CITY OF WESTFIELD, IN
Advisory Planning Commission Meeting Agenda_01_18_2022

BOARD OR COMMISSION: Advisory Plan Commission (APC)

Petition Number: 2201-ODP-01 & 2201-SPP-01
Project Name: Ditch Road Fire Station
Subject Site Address: 17001 Ditch Road (the “Property”)
Petitioner: RQAW Corporation
Representative: Westfield Fire Department
Request: Overall Development Plan & Primary Plat review of 2 Lots and a 36,530 square foot fire station on 30.9 acres +/- in the Maple Knoll Planned Unit Development (PUD) District.
Current Zoning: Maple Knoll PUD
Current Land Use: Vacant
Approximate Acreage: 30.9 acres +/-
Property History: Maple Knoll PUD ([Ord. 04-02](#), 02/09/2004)
Staff Reviewer: Caleb Ernest, Senior Planner

The comments contained herein are in review of the filed Overall Development Plan and Primary Plat scheduled for the December 21, 2021, Technical Advisory Committee meeting.

Courtyards at Spring Mill Updated Concept Plan

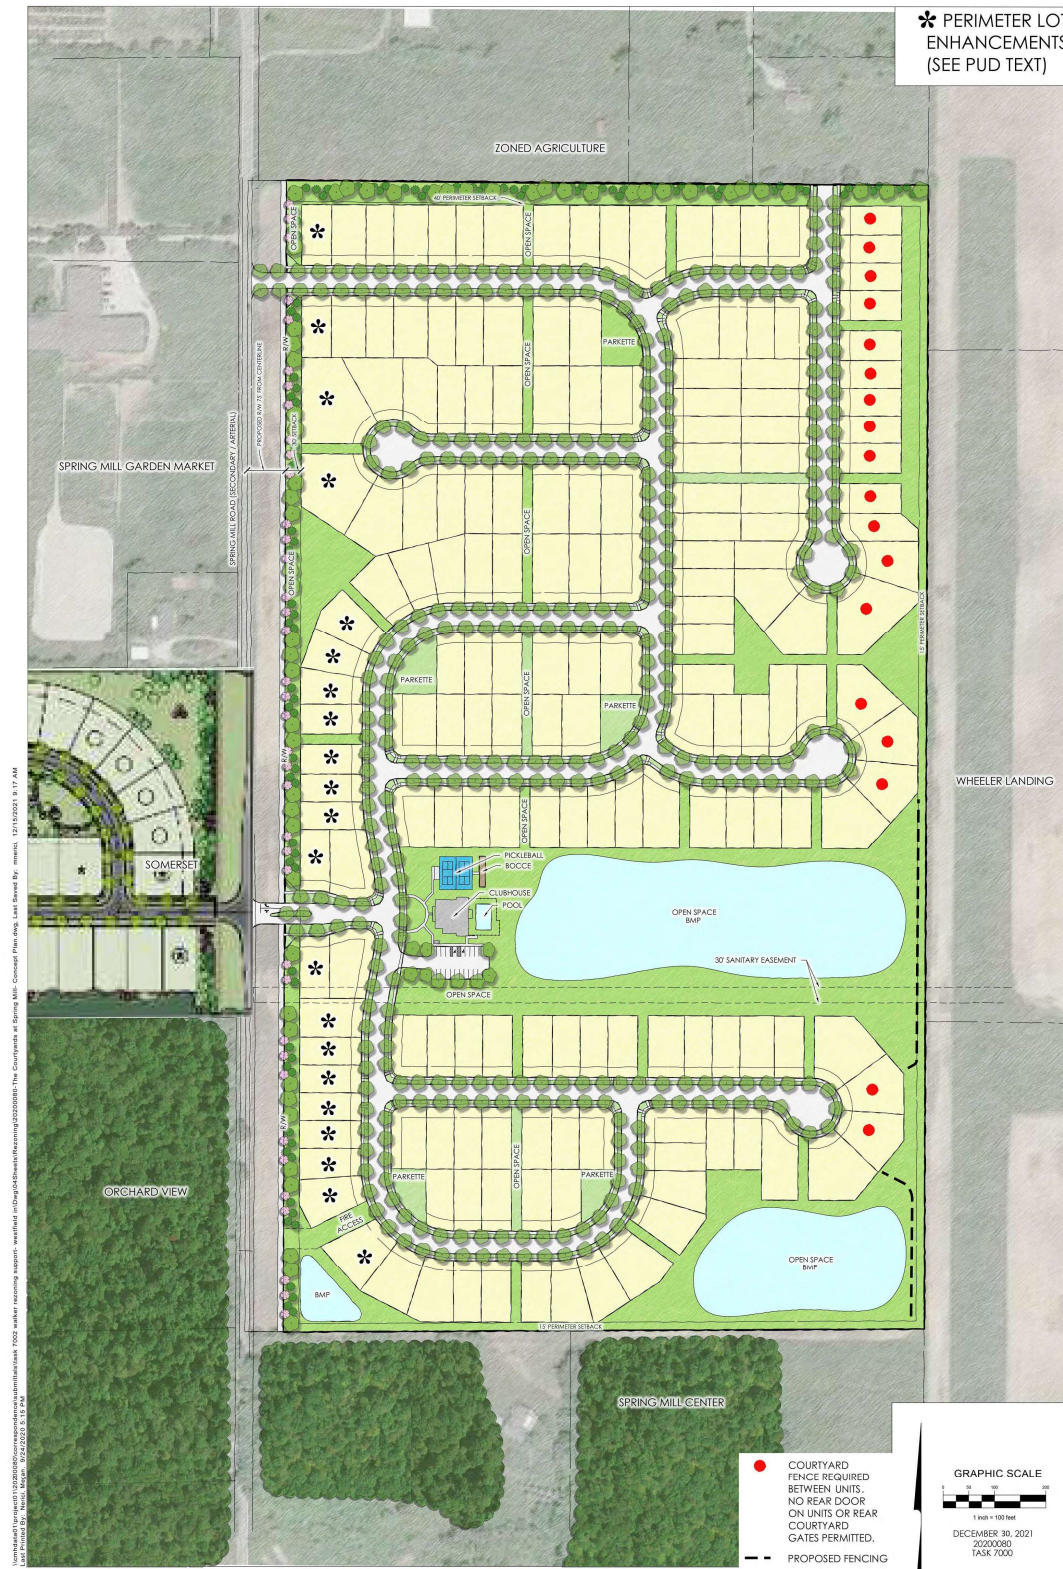
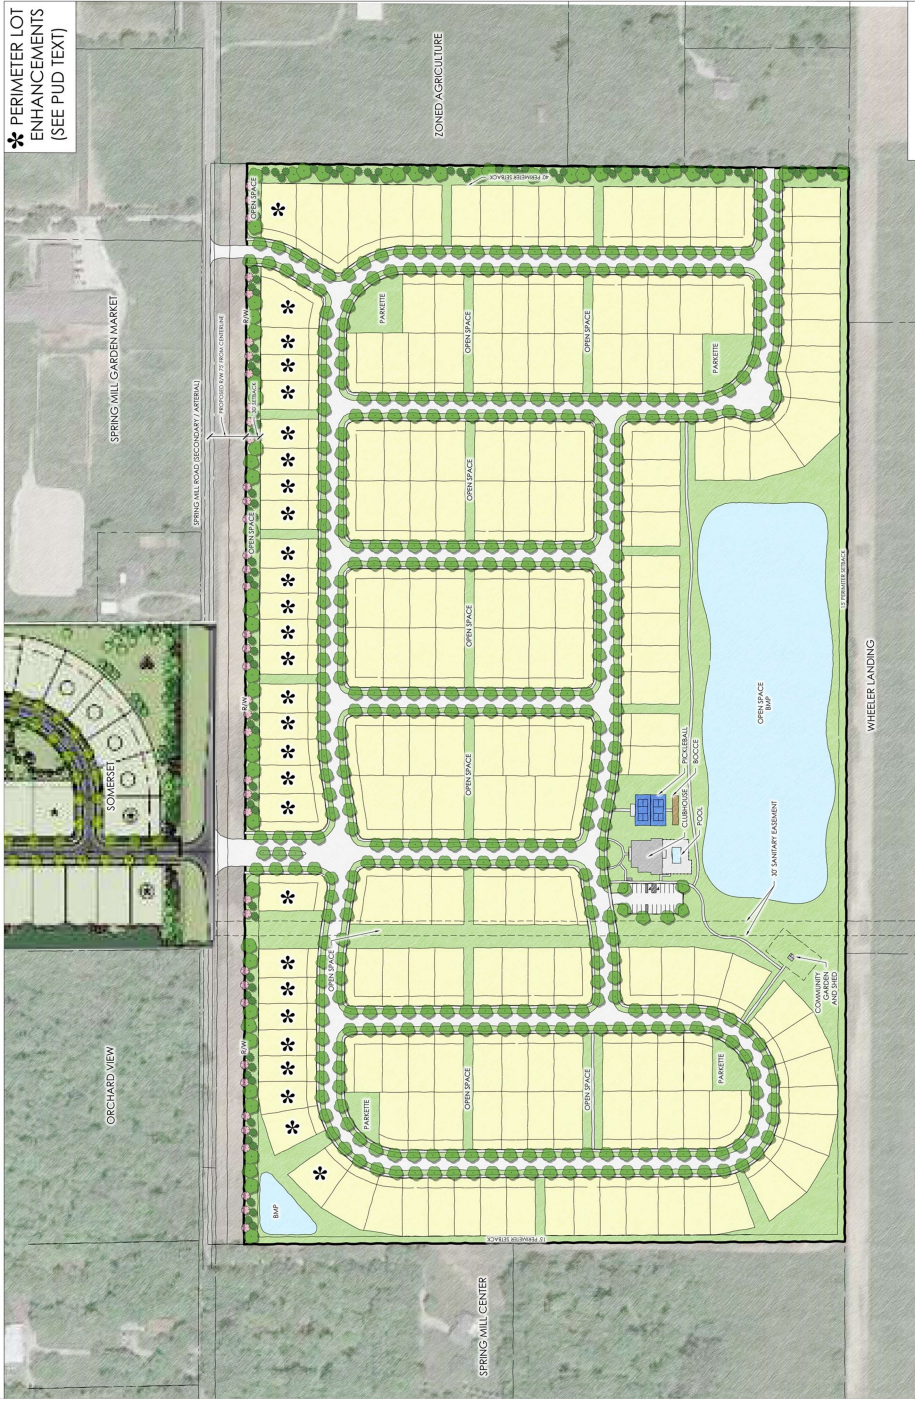
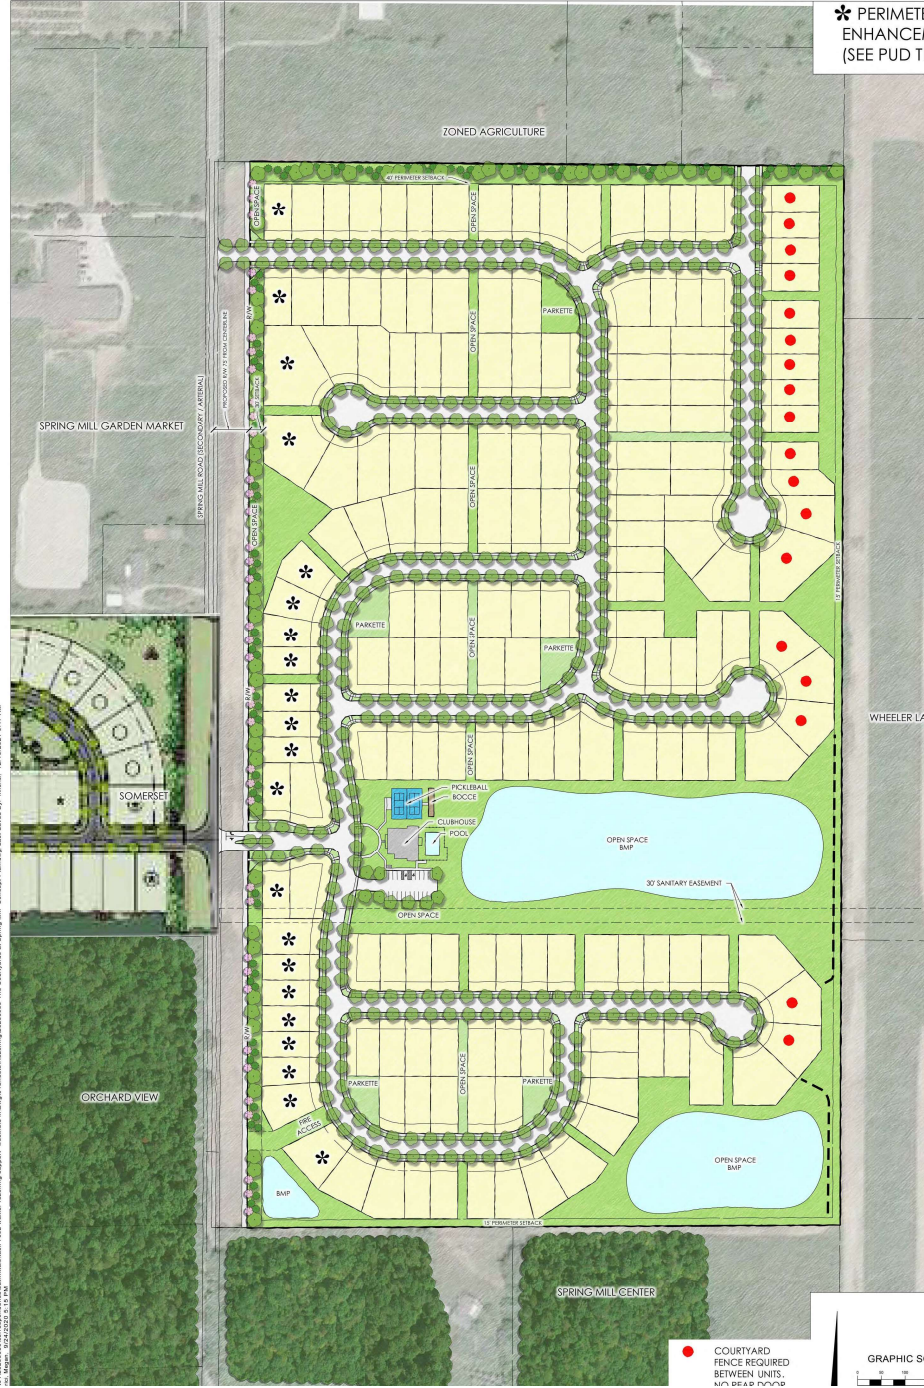
- Number of homes reduced by 14 to 184
- Age Restricted Community standards added to PUD rather than just age targeted
- Concept Plan Modified to eliminate grid street pattern
- Architectural Enhancements for all homes and in particular those next to Spring Mill Road
- Amenity Enhancements and timeline established
- Enhanced Buffer along Spring Mill Road with undulating mound in addition to landscaping and 4-board fence
- Perimeter separation along east Property line enhanced with setback, fence and pond reconfiguration (no gate or home access and ornamental metal fences)
